Colton Joint Unified School District

ADDENDUM NO.02

For
Bid No. 26-32FAC
Jurupa Vista Elementary and Ruth O Harris Middle School Exterior Painting
Project No.26-55
Colton Joint Unified School District

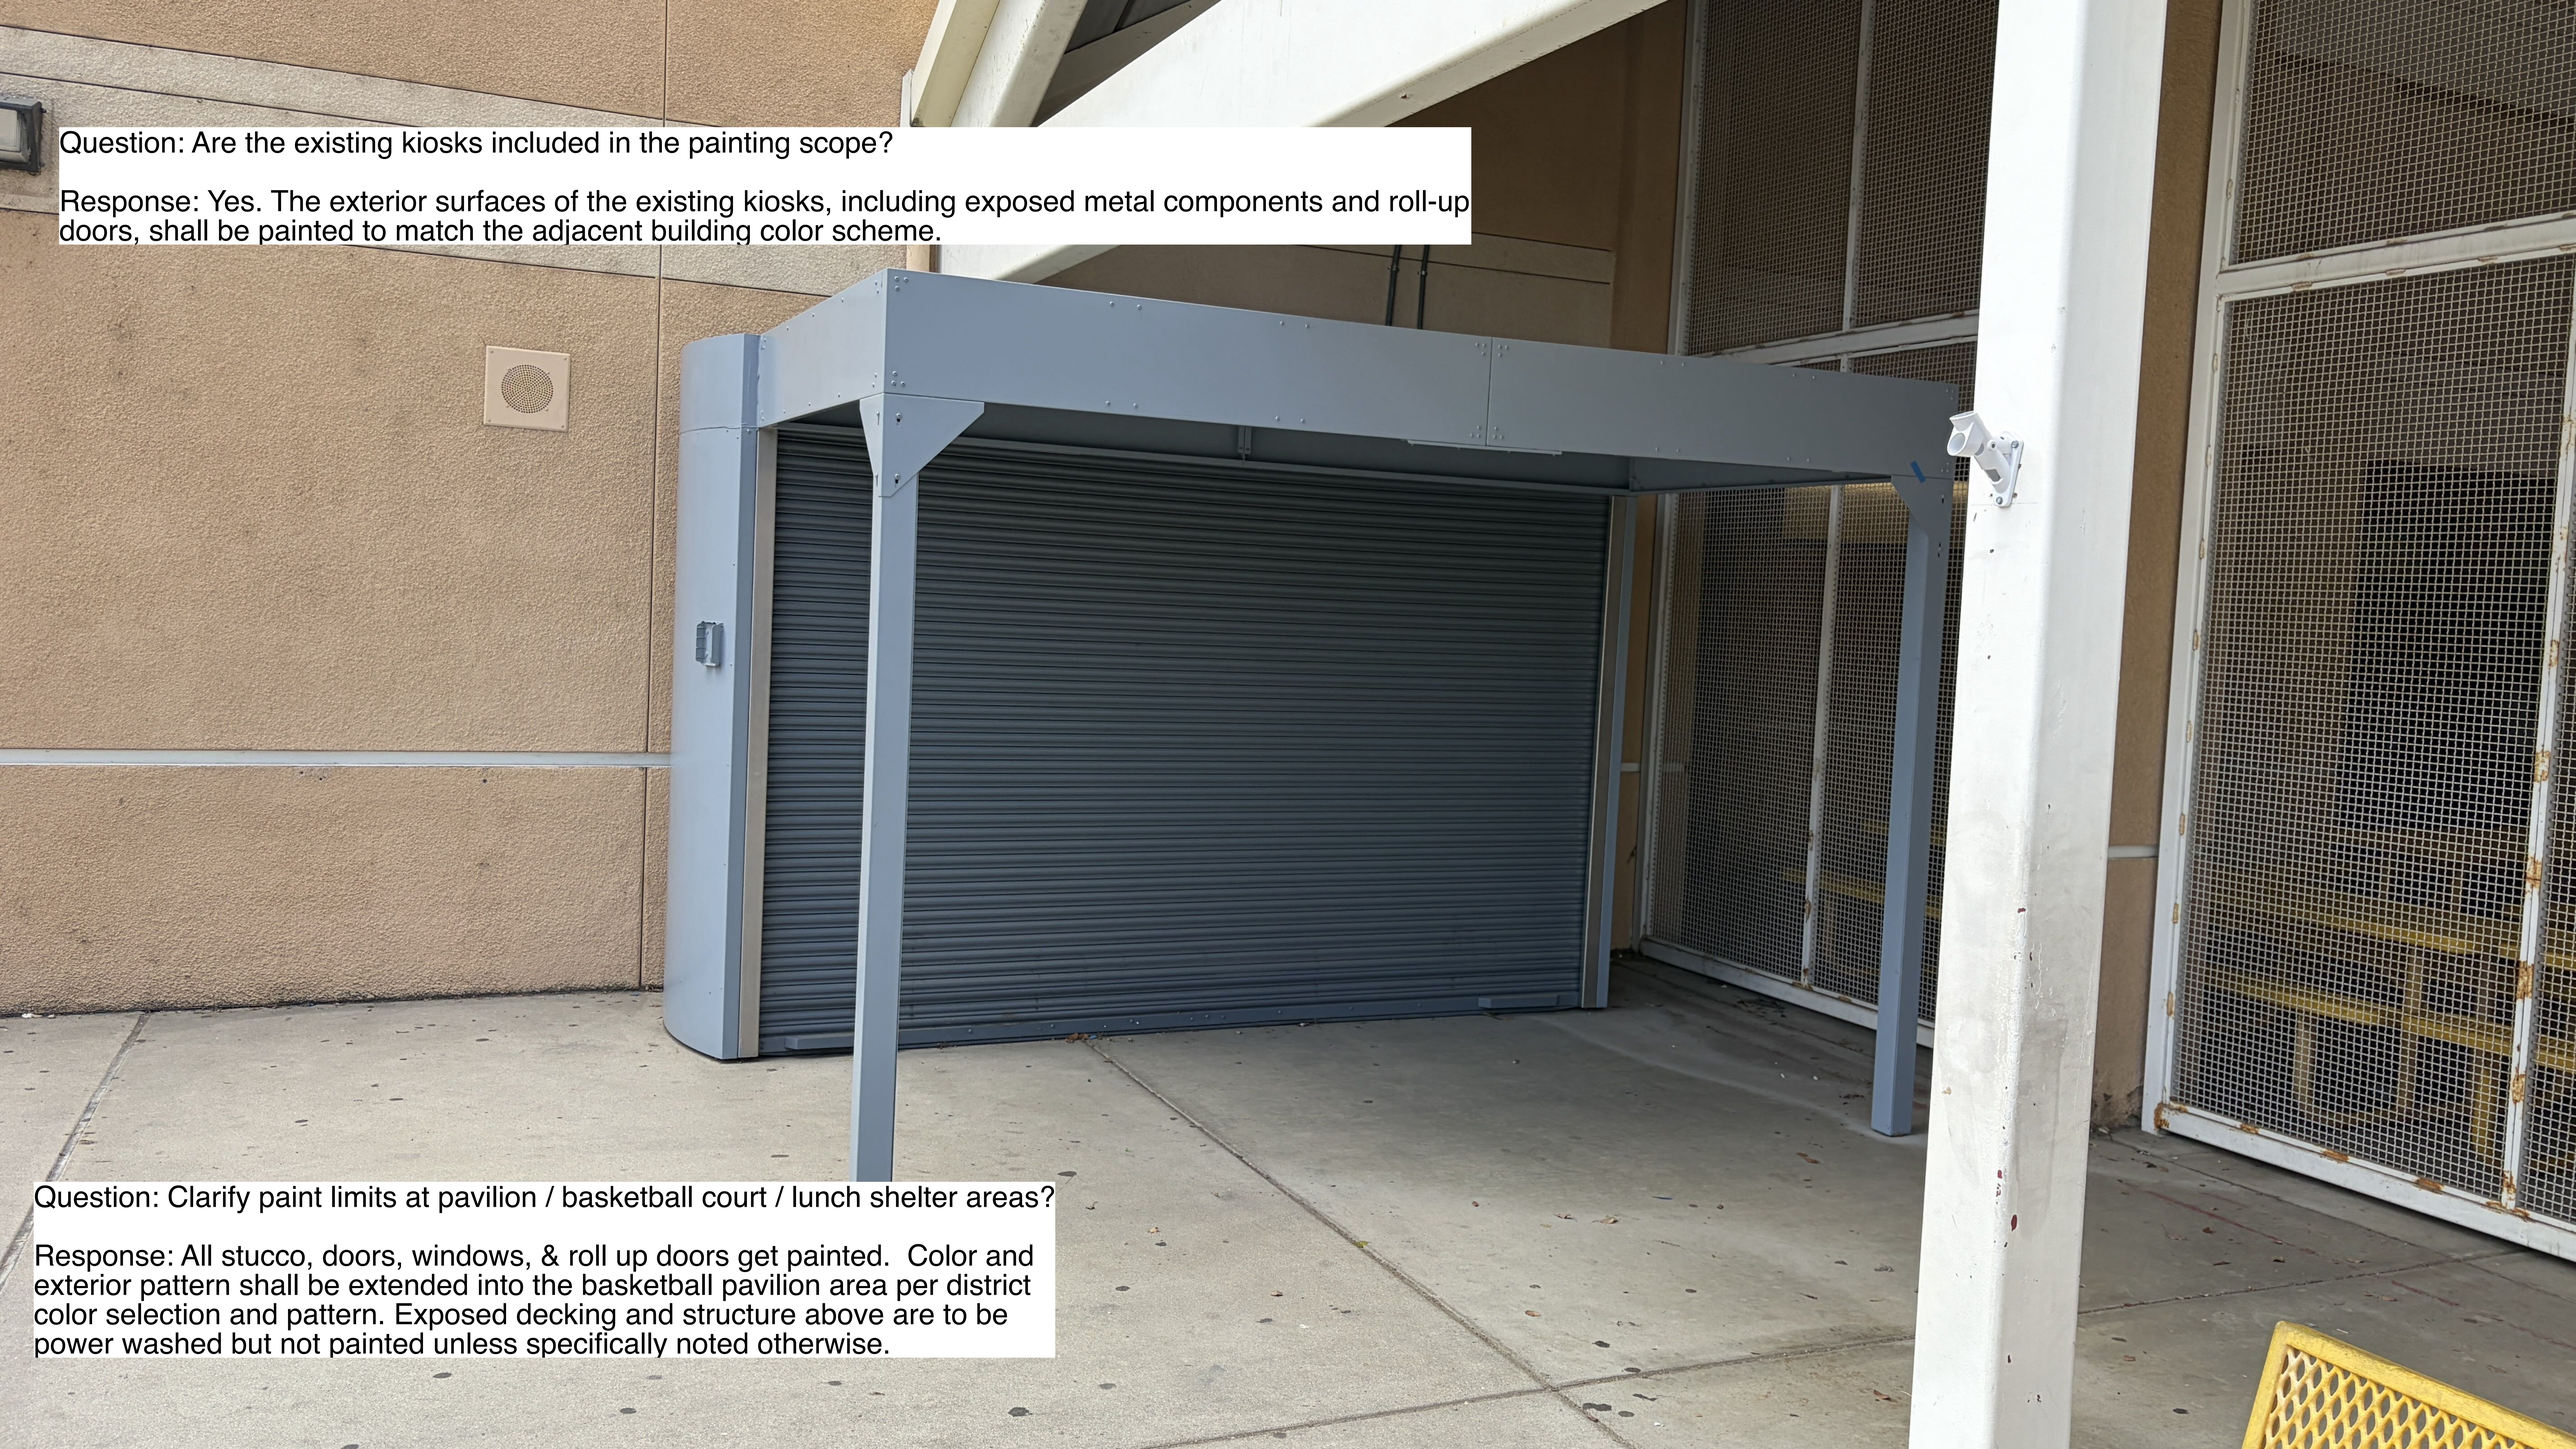
Question: Will window frames be painted?

Question: Do door interiors get painted with door exteriors?

Question: Administrative roof office clock to be painted?

Question: Clarify paint limits at pavilion / basketball court / lunch shelter areas?

Response: Existing clear anodized aluminum frames shall remain unpainted. Existing storefront assemblies, entry doors, door frames, and adjacent windows shown in the project renderings shall be painted.

Response: Yes, door interior shall be painted to match the interior wall color. Where storefront occurs, the entire storefront system shall be painted.

Response: Yes, per district approved color

Response: All stucco, doors, windows, & roll up doors get painted. Color and exterior pattern shall be extended into the basketball pavilion area per district color selection and pattern. Exposed decking and structure above are to be power washed but not painted unless specifically noted otherwise.

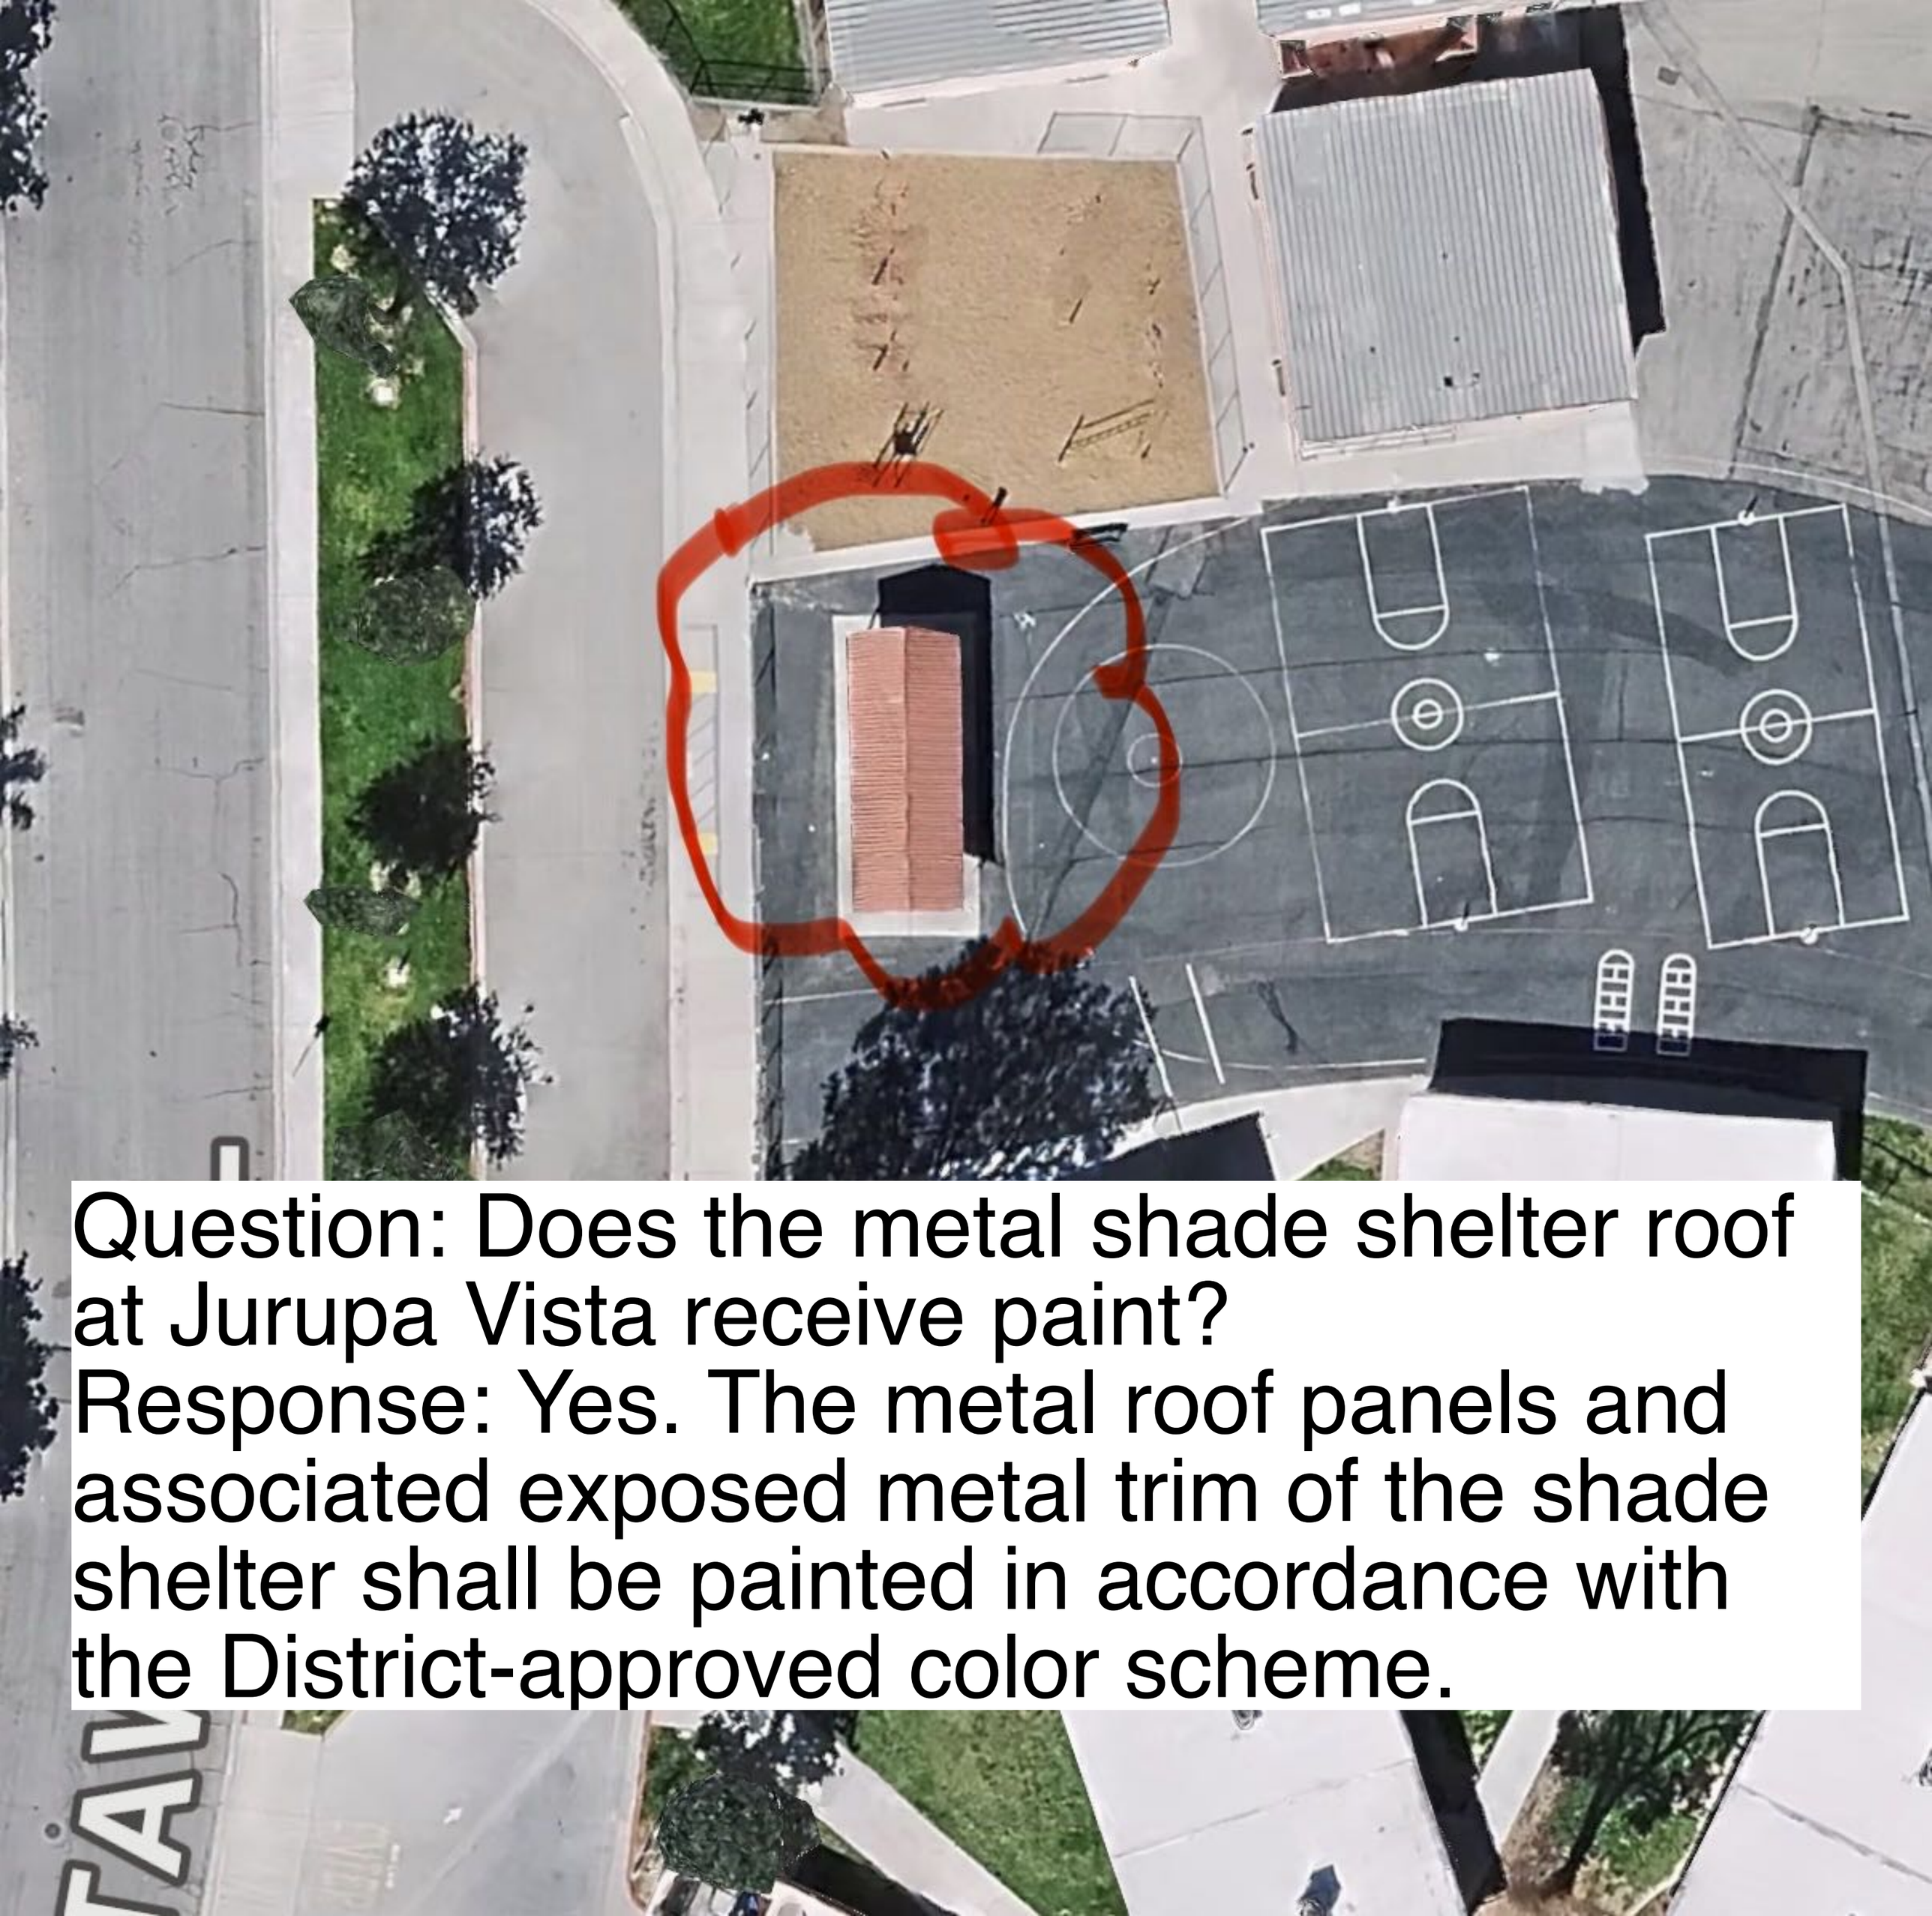
Question: Room & bldg. signage to be remove and replaced?

Question: exterior Bldg 900 & Library murals to be painted or protect in place?

Question: Do underside of roof / exterior exposed metal detail in common areas get painted

Response: Yes. Remove and reinstall signage.

Response: Protect in place

Response: All exposed decking shall be painted light grey. Color to be determined.
